PC14 Council Reply Attachment 4 – Information record of changes made to planning maps as part of S42A Reports, including corrections to memorandum already provided to the IHP.

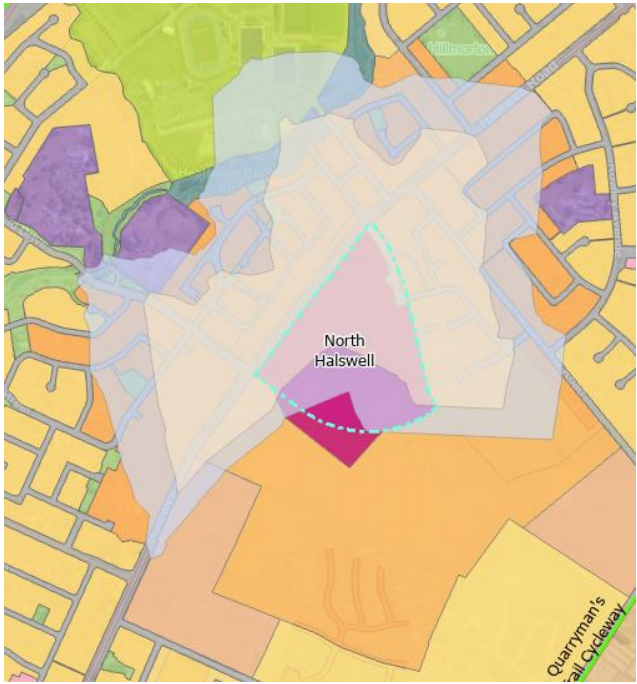
Entry #	Type	Source / Submitter(s)	Nature of additional change(s)	Reasons for change(s)	Notified & s42A Recommendation	S42A Officer
#1	Mapping Planning Map: 48 & 47	#879 – Rutherford Family Trust [Carlin Rutherford]	2 Crest Lane, Mt Pleasant. Remove Residential Hills Precinct, apply Suburban Hill Density Precinct.	The submitter did not present to the Panel, but subsequently made contact regarding the mapping error. FUZ was not considered appropriate for the site as the scale of the operative Monks Spur/Mt Pleasant Density Overlay was not sufficient to warrant a zone change, nor was it able to be argued as a qualifying matter. The initial application of the Residential Hills Precinct appears to be in error as the FUZ controls would seek to manage the overall site. With the recommendation to zone the site MUZ, consideration needs to be given to the LPTAA response, which is applicable to the site given its far proximity to an applicable bus route. The Suburban Hill Density Precinct should subsequently be applied, aligning with the zoning res	Notified: FUZ with Residential Hills Precinct Recommended: MRZ with Residential Hills Precinct	Ike Kleynbos / Ian Bayliss

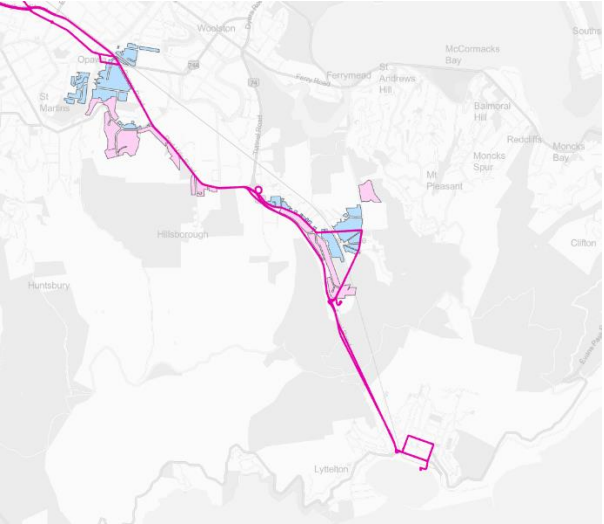
#3	Mapping Planning Map: 50	JWS – Planning Experts – Cashmere Worsleys ODP Area – 4 Dec 2023 #257 – Cashmere Land Developments Limited	Cashmere and Worsleys Development Plan area – 235 Worsleys Road (Lot 525 DP 515978) and 245 Worsleys Road (Lot 524 DP 515978). Remove Suburban Hill Density Precinct, except for the aforementioned sites. Sites with this precinct should not also have the Residential Hills Precinct, which should apply to residual areas (shown with red dots below). 	Please refer to the JWS document. To summarise, the LPTAA logic has been to only apply this to areas reasonably anticipated to see uplift – i.e. not newly developed areas as propensity to develop would be extremely low, removing the need for a QM response. Only the two sites recommended remain undeveloped and would have merit in applying the QM. The Residential Hills Precinct would be superfluous as the minimum allotment size is the same for the Suburban Hill Density Precinct. The former Precinct should only apply in developed areas to manage vacant allotments.	Notified: FUZ with Residential Hills Precinct (partially). Recommended: MRZ with Suburban Hill Density Precinct and Residential Hills Precinct.	Ike Kleynbos / Ian Bayliss

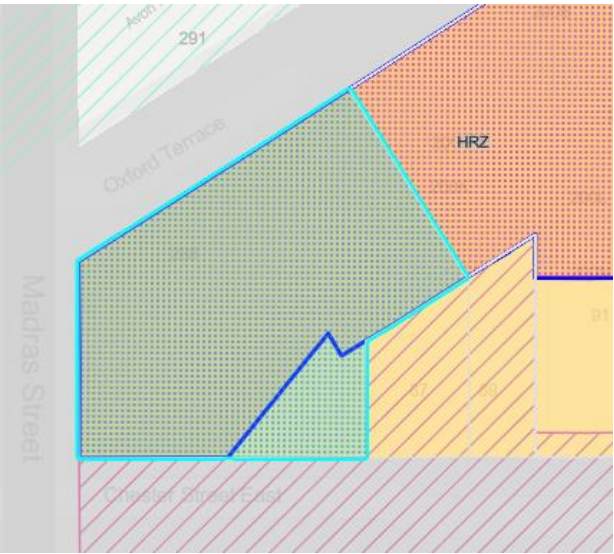
#4	Mapping Planning Map:	#760 – ChristchurchNZ #751 – Christchurch City Council	Retain operative zoning as OCP – Open Space Community Park Zone.	This was inadvertently changed to LCZ through notification and s42A recommendation.	Notified: LCZ	Kirk Lightbody

Entry #	Type	Source / Submitter(s)	Nature of additional change(s)	Reasons for change(s)	Notified & s42A Recommendation	S42A Officer
	39 Buchan Playground – 41 Buchan Street			This is an error. The error was noted in the submissions of CCC (#751) and ChristchurchNZ (#760).	Recommended: LCZ Right of Reply: OCP
